ADDENDUM NO. ONE TO THE BIDDING DOCUMENTS FOR:

111 Upgrade MRI Suite
VA Project No. 695-14-145

**VA Medical Center
5000 West National Avenue
Milwaukee, Wisconsin 53295**

Drawing Number
E-131

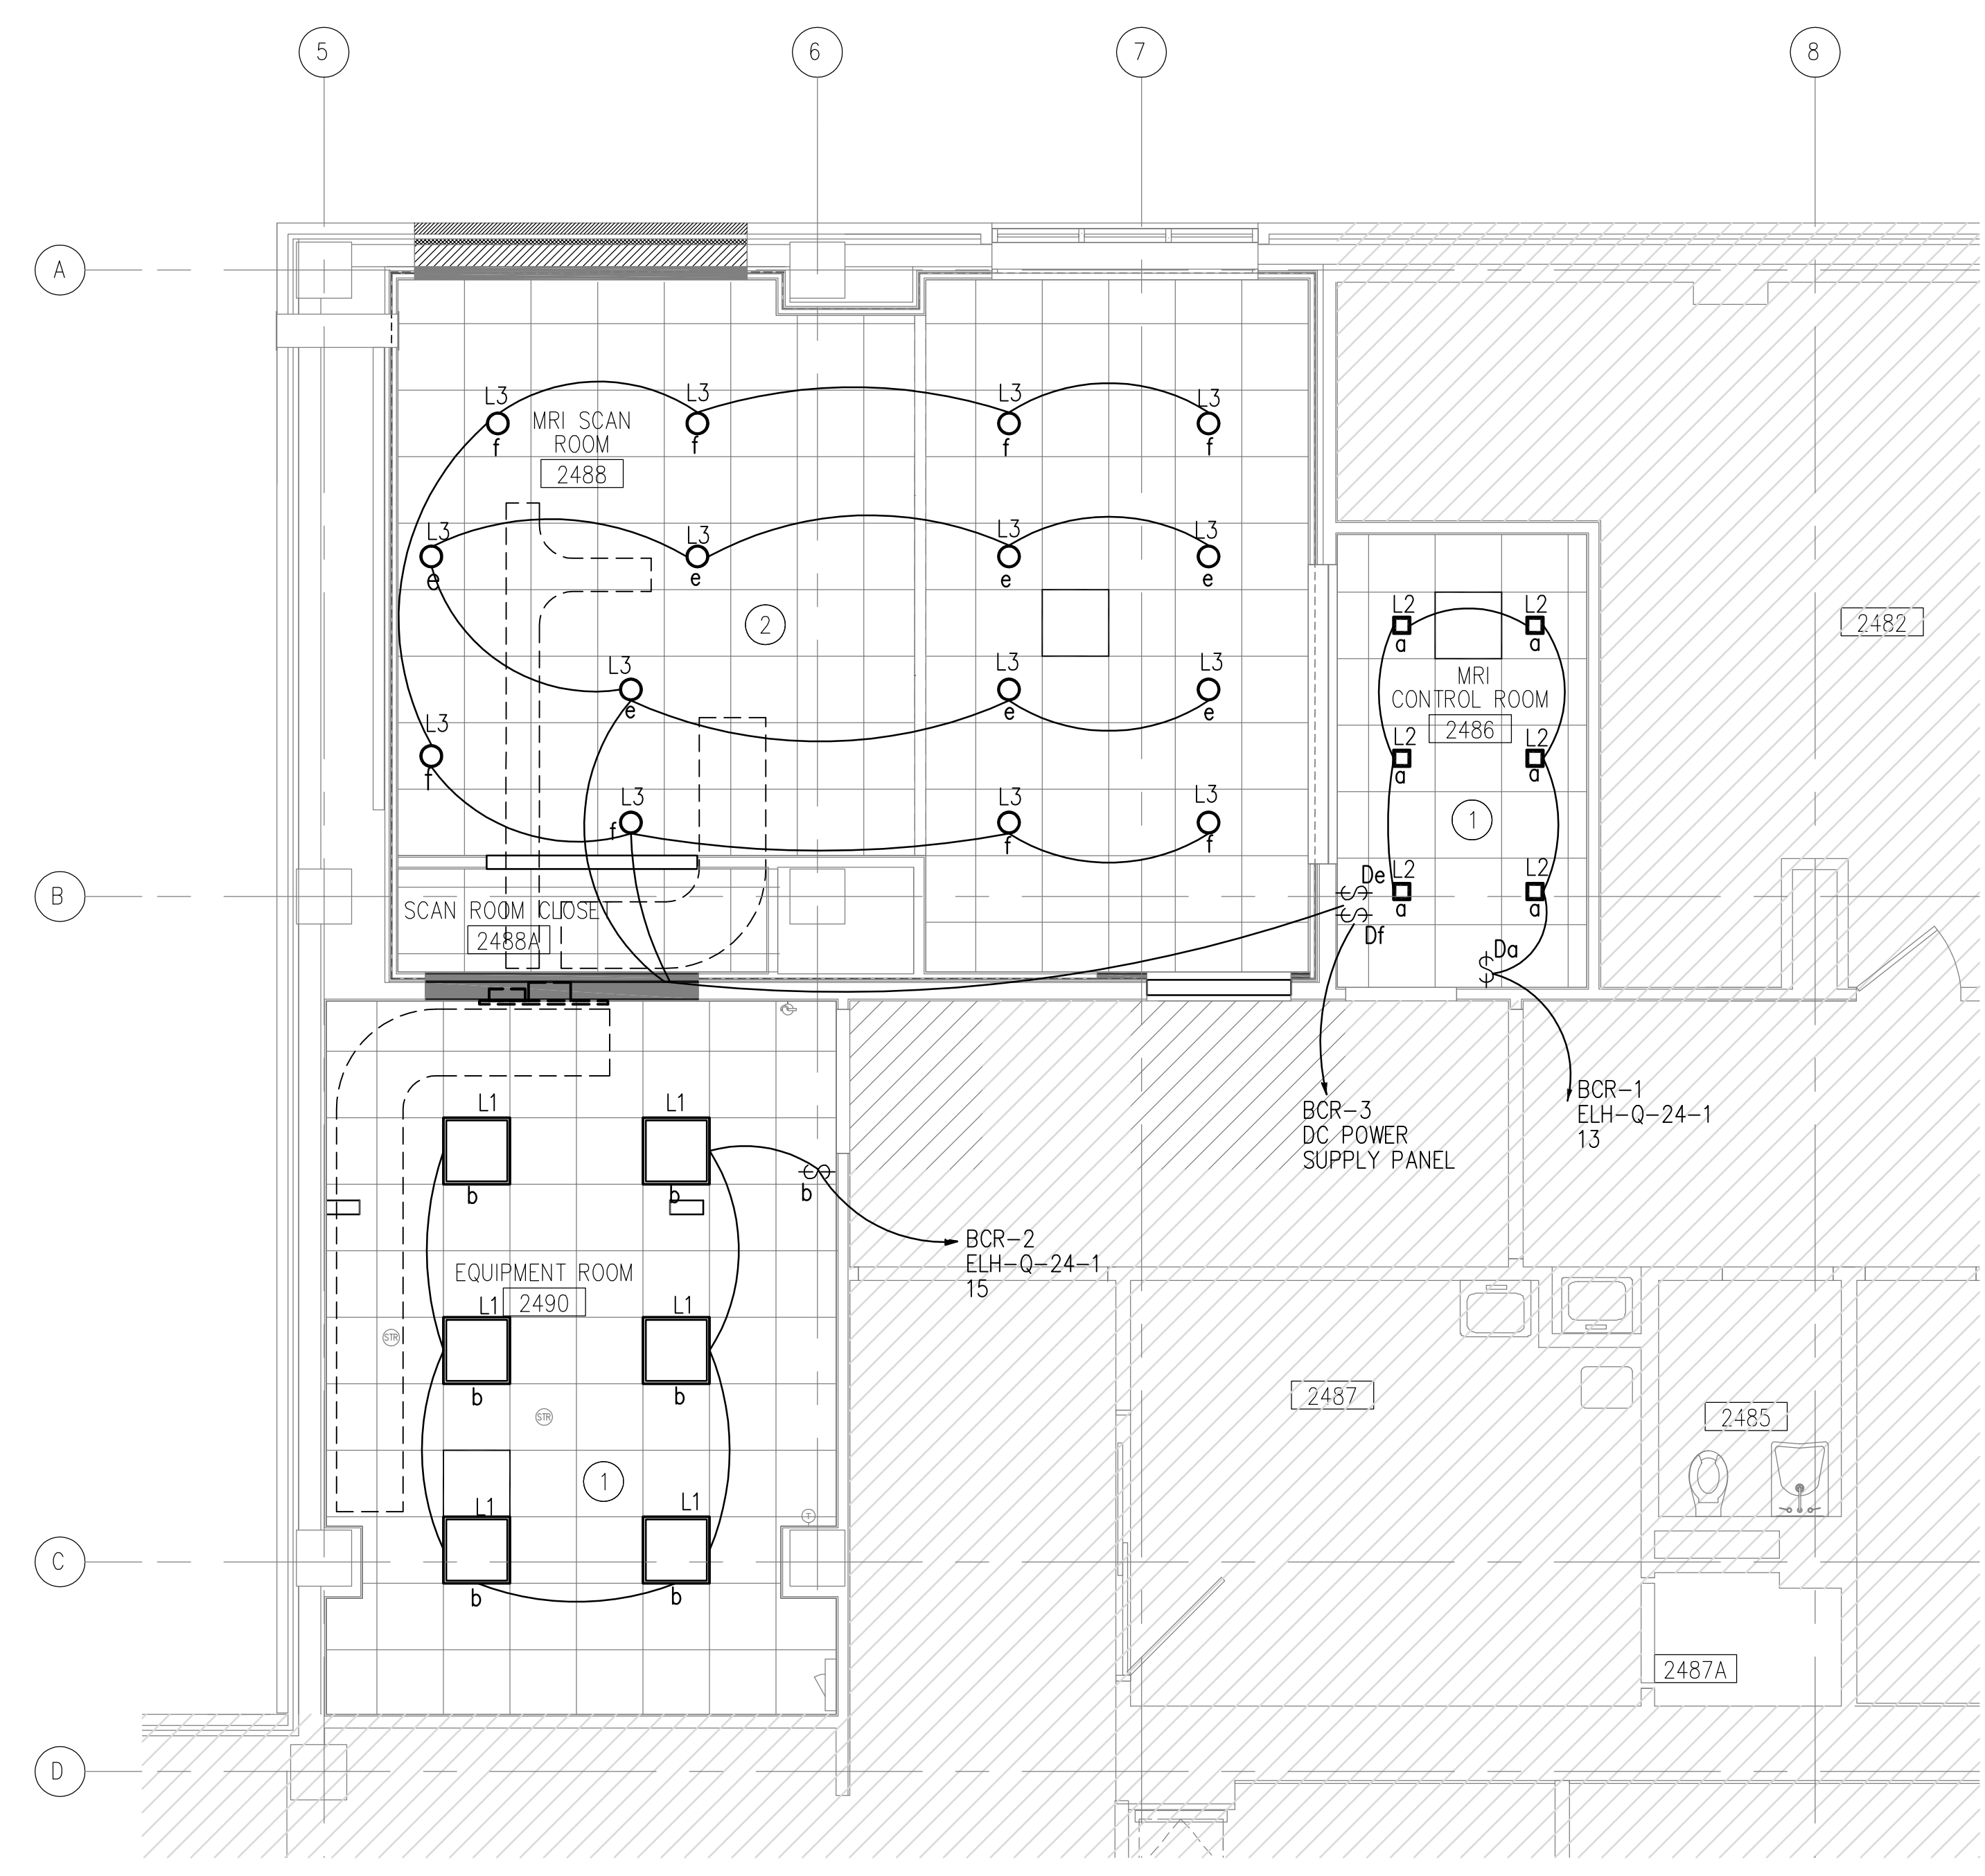
Drawing SHEET E-131:

- 1.1 Revised – Luminare Schedule Type L2.

Question #23: AHJ (VA) required battery-powered lighting not related to illumination of a means of egress is required at the following locations: Locations where deep sedation or general anesthesia are administered (not limited to inhalation anesthetics). Monthly 30-second testing, plus annual 30-minute testing; The illumination levels will need to meet the end user's needs (typically can range from 30-100 foot candles

Response: Battery Back Up lighting cannot be accommodated within the MRI room itself, however, a battery backup lighting fixture will be provided within the Control Room to accommodate this requirement, see revised drawing sheet E-131.

Project Number
695-14-145
Building Number
111
Drawing Number
ED-101

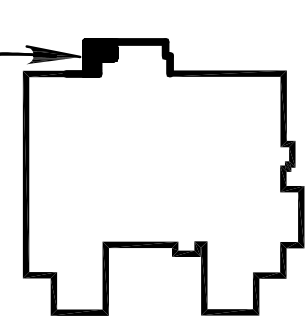
Drawing SHEET ED-101:

- 1.1 Description – Demolition Key Note #24 added. Existing fire alarm and strobe to be removed and relocated. Existing fire alarm and strobe will be relocated east, just outside of the temporary construction barrier wall. This will be fire alarm and strobe and permanent location

Question #6: Will strobe at 2490 need to be relocated and functional during construction?

Question #15: Sheet ED-101, Electrical floor Plan Key Notes - Detail Please define "to the extent possible" in reference to the conduit removal indicated in notes 1, 4, & 8.

Response: Please see revised drawing SHEETS ED-101 and E-101. Existing fire alarm strobe will be removed and permanently relocated outside of the temporary construction barrier wall (infection control room).

Response: Remove to nearest junction box. General Contractor to field verify existing junction box locations.

23. CONTRACTOR SHALL REMOVE THE ABANDONED DISCONNECT SWITCH AND PREPARE THE THE SITE FOR OF NEW AHU-1 EXHAUST FAN VFD INSTALLATION.
24. CONTRACTOR SHALL REMOVE EXISTING FIRE ALARM/STROB AND STORE IN SAFE PLACE FOR REINSTALLATION.

Project Title	
111 UPGRADE MRI SUITE	
Location	CLEMENT J. ZABLOCKI VA MEDICAL CENTER MILWAUKEE, WISCONSIN
Date	1/5/2015
Checked	AC
Drawn	CM
Project Number	695-14-145
Building Number	111
Drawing Number	G-102

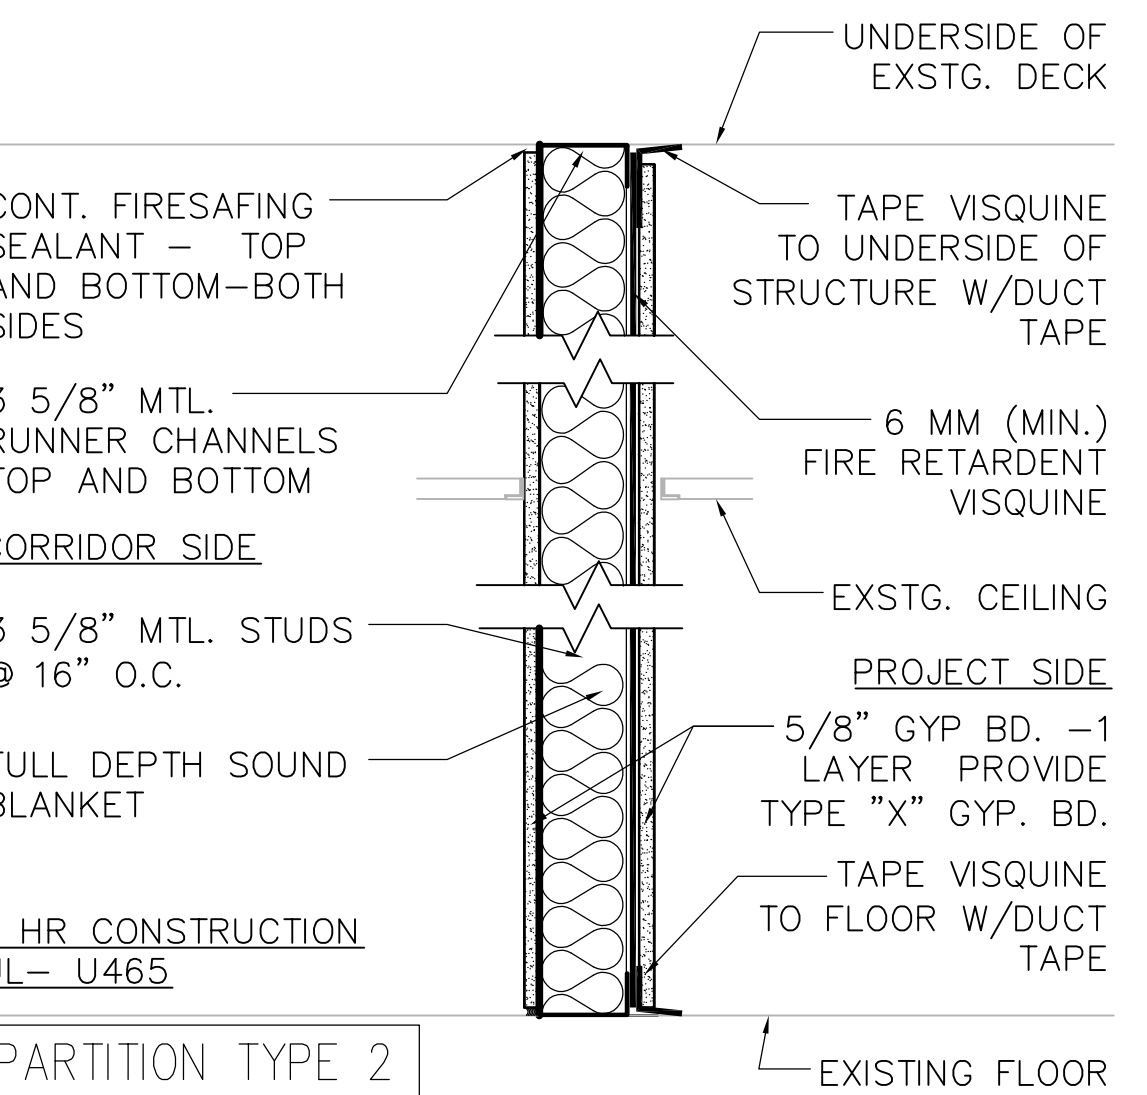
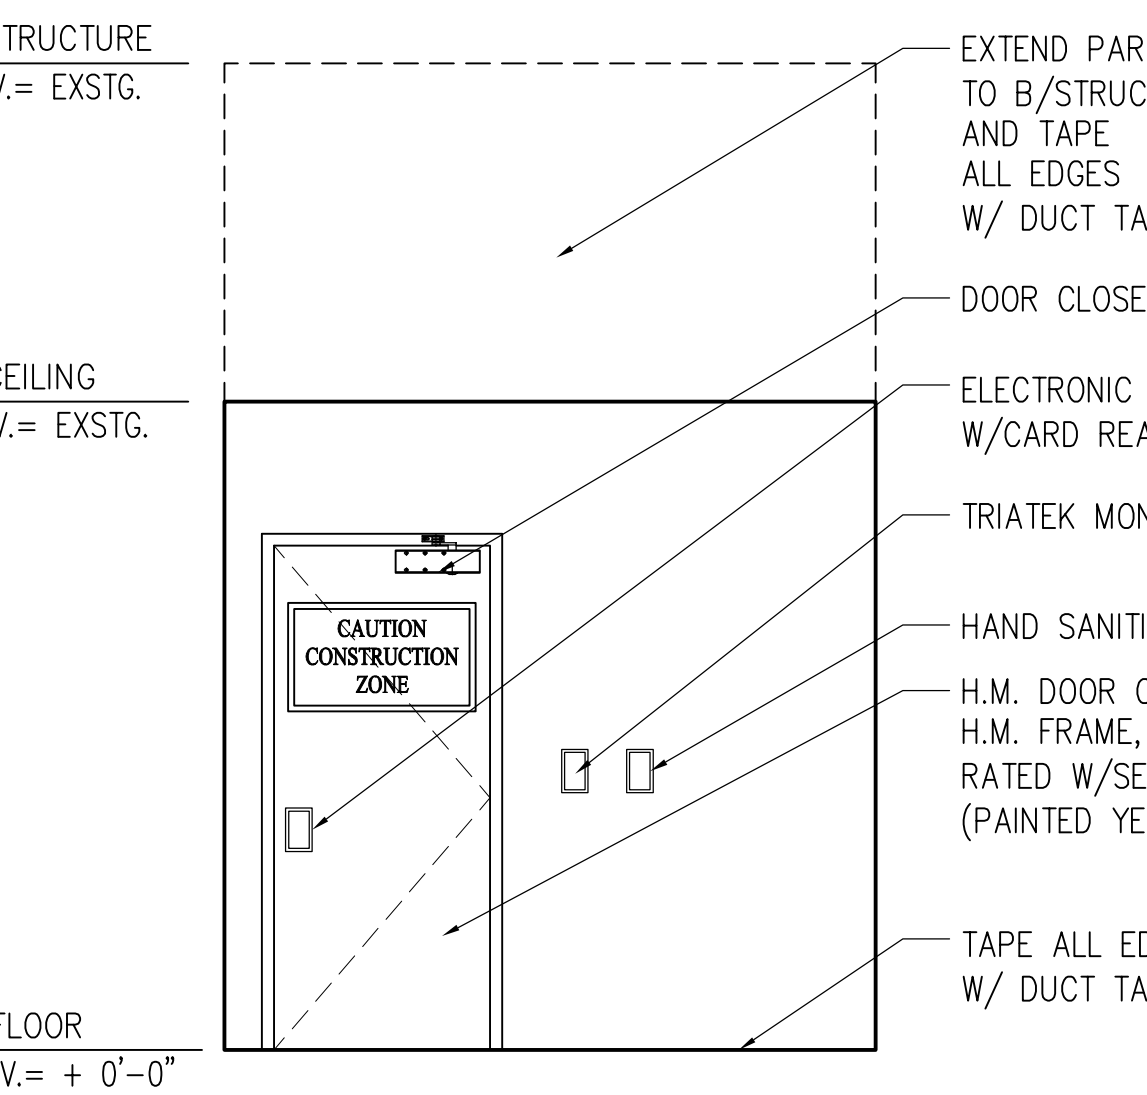
Drawing SHEET G-102:

- 1.1 Revised – Door swing to Equipment Room 2490 door has been corrected to show door swings out.
- 1.2 Revised – Swing to temporary construction door swings out.

Drawing Number
MH-102

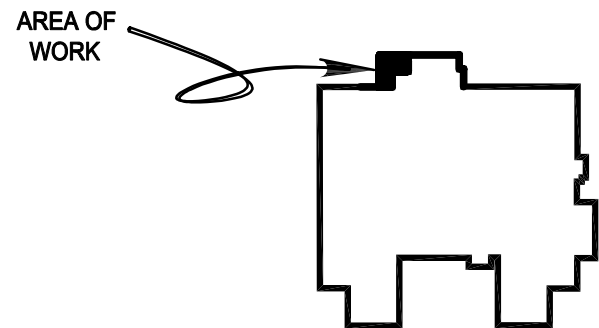
Drawing SHEET MH-102:

- 1.1 Revised – Demolition Key Note #4 will include sizes of existing glycol pipes to be demolished.

Question #3: Sheet 1/MH-102 Key Note 4 describes the removal of the existing rooftop unit along with associated glycol piping to below roof. Sheet 2/MH-102 shows a new AHU-2488 mounted on the roof and Key Note 5 describes new hot and chilled glycol lines connected to this unit. No existing glycol piping is shown on any Mechanical sheet. Does both hot and chilled glycol pipe exist?

Existing 1 ½" glycol hot water and 2" glycol chilled water piping to be removed

Response: BAE Response: The existing rooftop unit is currently being supplied with existing 1 ½" glycol hot water and 2" glycol chilled water piping.
